Section 75W Modification to MP 09_0044 – Minor Design Changes to Façade and Terrace

Park Hyatt Hotel, The Rocks

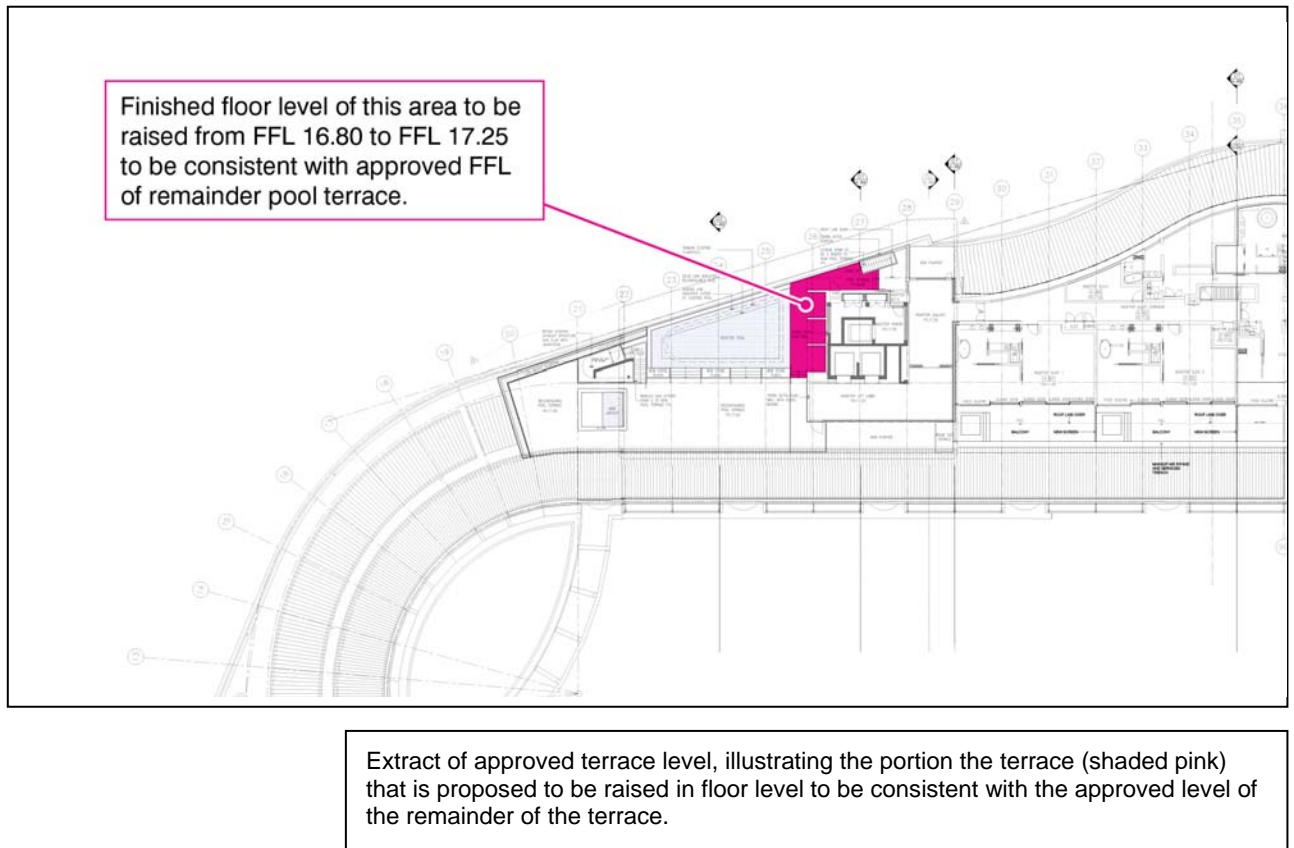
- Change to pool terrace design by reducing the extent of the pool terrace by some 1.2m to 2.5m at its western end level. This results in a reconfiguration of the layout of the western end of the pool terrace including relocation of the Jacuzzi and deletion of Stair 5.
- The raising of the finished floor level of the pool terrace level in the north-eastern area, east of the pool by 0.45m (from FFL 16.80 to FFL 17.25) to provide a consistent floor level to the approved FFL level of 17.25 over the majority of the pool terrace level, as illustrated in the diagram below.
